# **TECHNICAL BULLETIN**

FAM-A-0036-B

# **Changes in F2-40BL Battery Parts**

F2-40BL

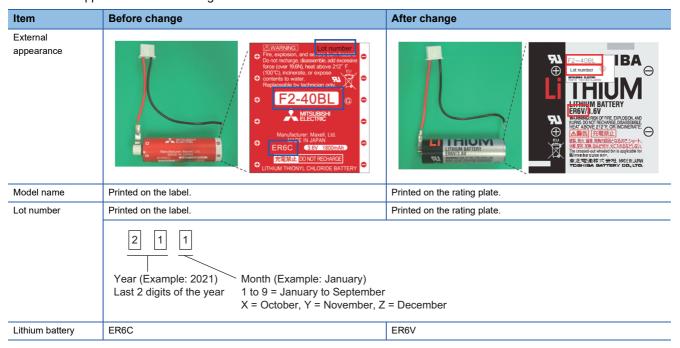
The external appearance and lithium content will be changed.

The external appearance will be changed as shown below.
